ADA Curb Ramp New Construction Inspection Form (Parallel)

NW Curtis St

23885.56

NW Pacific

PARALLEL RAMP (PL)

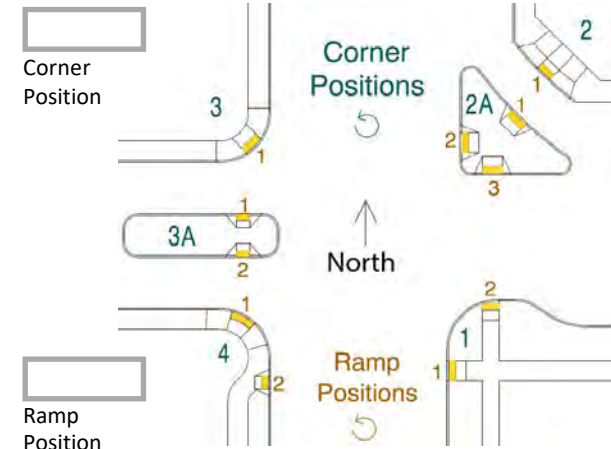
2.6 $\leq 2.0\%$ ☐ $> 2.0\%$ ☒

8.5 $\leq 8.3\%$ ☐ $> 8.3\%$ ☒

midblock west side, IITD
